January 2020
FL841A
NHTSA #19V-869
Transport Canada #2019-611

Subject: FCCC School Bus Chassis Fan Clutch Bolts

Models Affected: Specific Model Year 2020-2021 FCCC B2 school bus chassis (Thomas Built Buses Saf-T-Liner C2) manufactured January 21, 2019, through October 11, 2019, and equipped with a DD5 engine.

Fig. 1, Fan Clutch Assembly

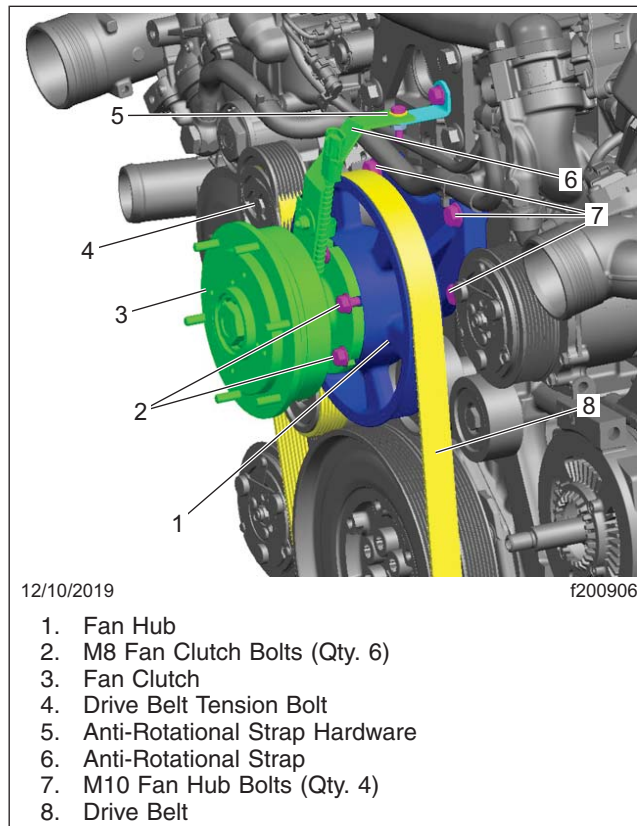
1. Check the base label (Form WAR259) for a completion sticker for FL841 (Form WAR260) indicating this work has been done. The base label is usually located above the driver's window. If a sticker is present no work is needed. If there is no sticker, proceed with the next step.
2. Park the vehicle on a level surface, shut down the engine, and set the parking brake. Chock the tires.
3. Remove the six nuts that attach the fan blade assembly to the fan clutch and set the fan aside. Discard the nuts.
4. Disconnect the fan clutch connector.
5. Remove the bolt and nut from the anti-rotational strap and set aside. See [Fig. 1](#).
6. Loosen, but do not remove, the six fan clutch bolts. See [Fig. 1](#).
